MEMORANDUM

TO: Martha's Vineyard Commission
FROM: Eric Dray, Preservation Consultant
DATE: August 2, 2023
RE: DRI #718, 7 Arlington Avenue, Oak Bluffs – Replacement House

Figure 2. 03.06.2023, South Elevation, Existing and Proposed (sullivan + associates architects).

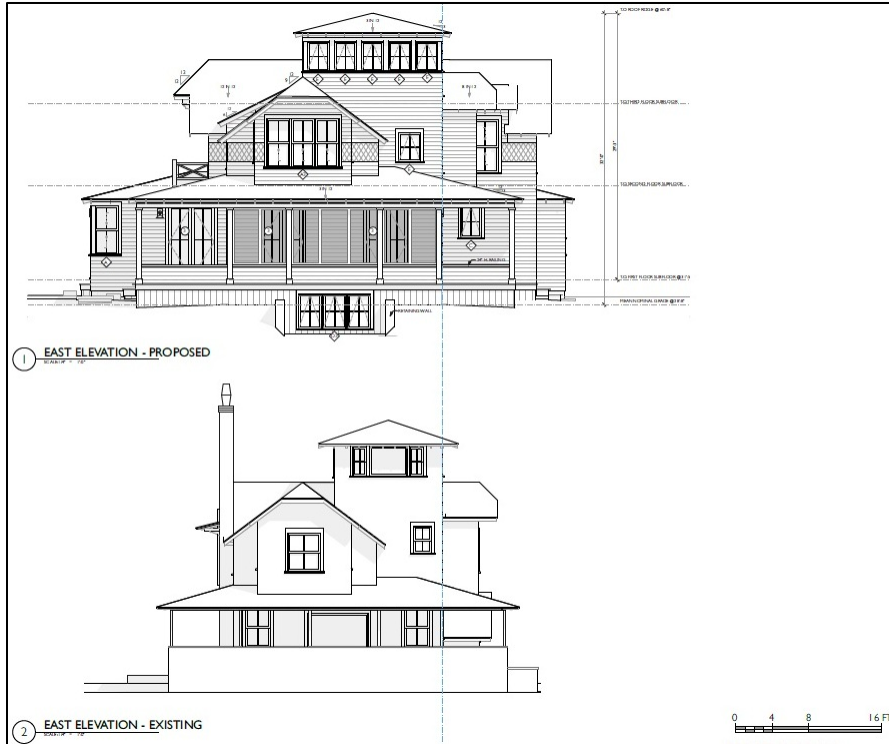
South Elevation (Figures 1, 2): The south elevation, while longer than the existing house, retains the same essential composition, including the cross-gable bay. A shed dormer spans most of the main roof slope. The 2023 version of the tower has retained the broader width on the south and north elevations shown in the 2022 drawing, and it is now rectangular in shape as a result. It is difficult with only the elevation drawings to determine whether this rectangular tower is at variance with the historical integrity of the original house.

The open porch, which spans much of the south, east and north elevations retains the shingled half-wall enclosure employed for the existing house. The use of turned posts shown on the 2022 and 2023 drawings, however, introduces an ornamental feature that does not, in my opinion, reflect the historical integrity of the existing porch which is supported by simple square posts.

The balcony on the cross-gable bay has been simplified in design with a shed roof that is more in keeping with the original house.

South Elevation (Figures 1, 2): The most significant reduction in massing appears to be the reduction in the length of the south (and north) elevation, pulling the overall footprint of the house back on the east side so that the footprint on the east side of the 2023 house approximately aligns with the existing house.

Figure 3. 06.14.2022, East Elevation, Existing and Proposed (sullivan + associates architects).

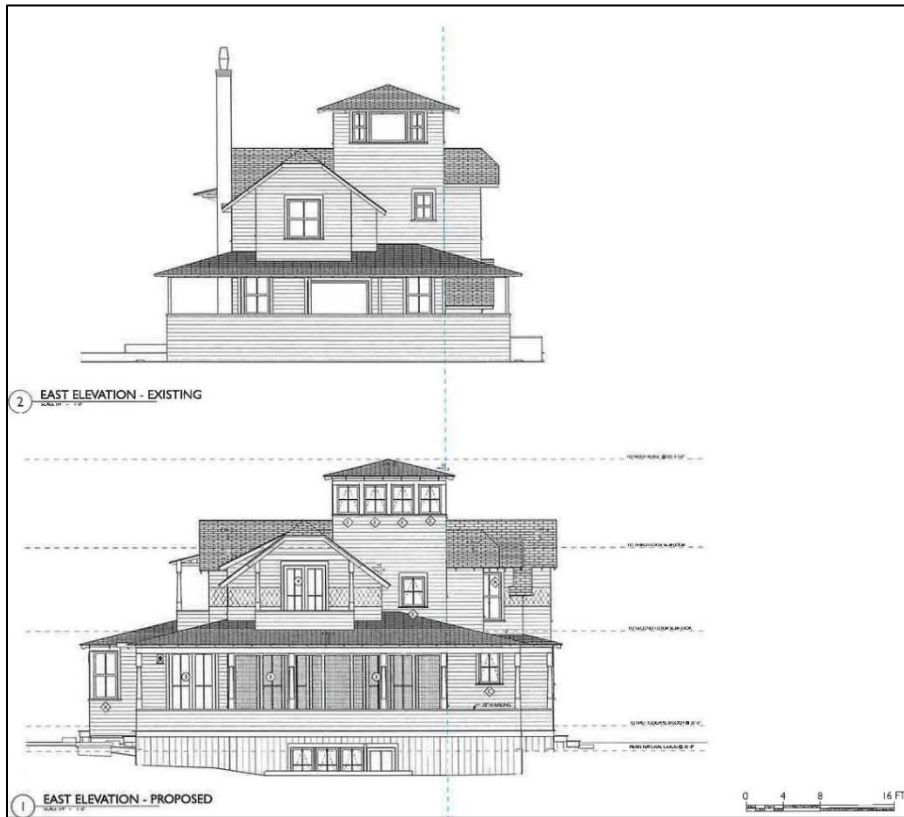
East Elevation (Figures 3, 4): The 2023 version of the east elevation has been improved with the narrowing of the tower to a width similar to the original, and the re-introduction of the open porch within the dormer (in this one respect, the design reintroduces a feature that had been removed from the existing house).

East Elevation (Figures 3, 4): The width of the tower has been reduced on the east and west elevations, and it is now the same width as the existing tower. The end gable has been reduced in size and massing by recreating the recessed balcony.

Figure 6. 03.06.2023, North Elevation, Existing and Proposed (sullivan + associates architects).

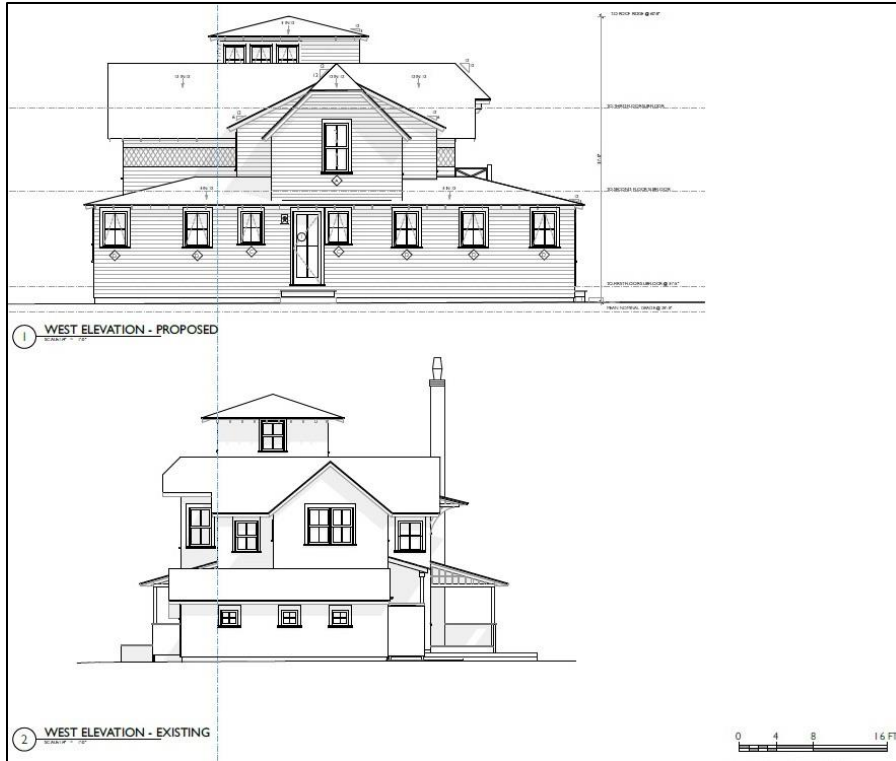
North Elevation (Figures 5, 6): The eastern half of this elevation is similar in design and massing to the existing house. The western half has been expanded. Shed dormers span much of the main roof slope. The feature which, in my opinion, could be made more reflective of the architectural integrity of the existing house is the new two-story bay that contains the main entrance. The 2023 design pulls that bay back so that it no longer projects beyond the porch. However, the gable roof appears more complicated in design including the introduction of cross-bracing. An improvement might be introducing another clipped gable roof and removing the cross-bracing, making it compatible with the existing dormer with clipped gable on that elevation.

North Elevation (Figures 5, 6): The new two-story bay represents one of the largest increases in massing to the house. On the 2023 drawing, this bay has been pulled back behind the wall plane of the porch, but it is unclear if that reduces the overall massing of that bay. One increase in massing on this elevation from the 2022 to the 2023 replacement design appears to be the extension of the shed dormer farther west.

Figure 7. 06.14.2022, West Elevation, Existing and Proposed (sullivan + associates architects).

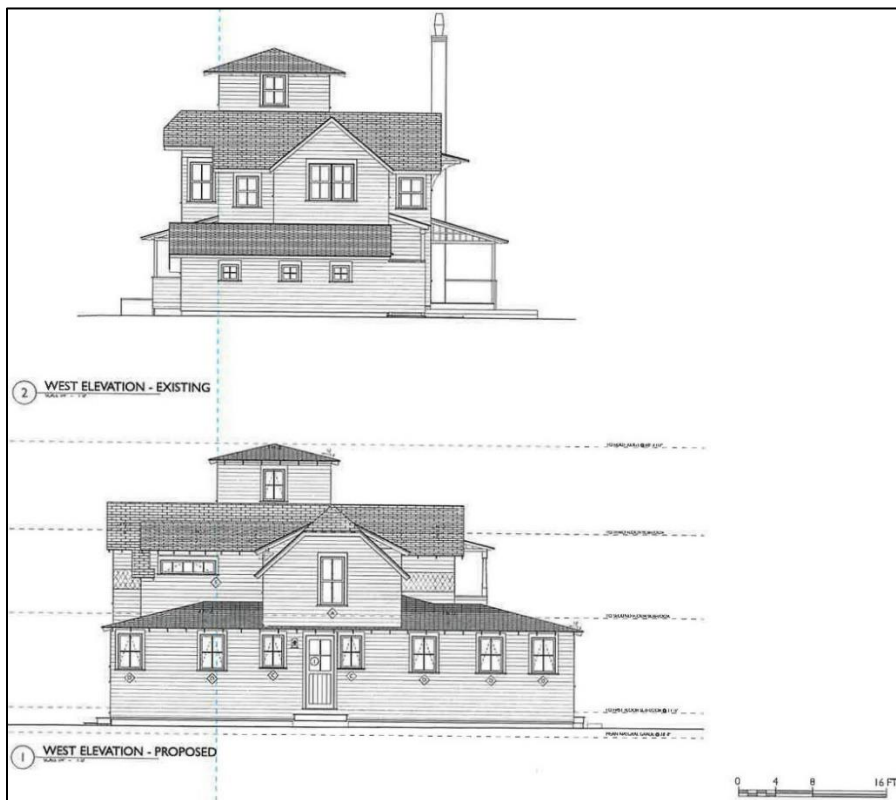
West Elevation (Figure 7, 8): The west elevation appears to represent the greatest expansion of the house. However, this elevation is the least visible from a public way. Despite the expansion, this elevation retains the simplicity in detail that characterizes the existing house. The west elevation also retains the gable-roofed form, although on the 2023 design, that gable roof now has a clipped gable.

The one-story component is substantially broader than the existing house and appears to be largely unchanged between the 2022 and 2023 versions.
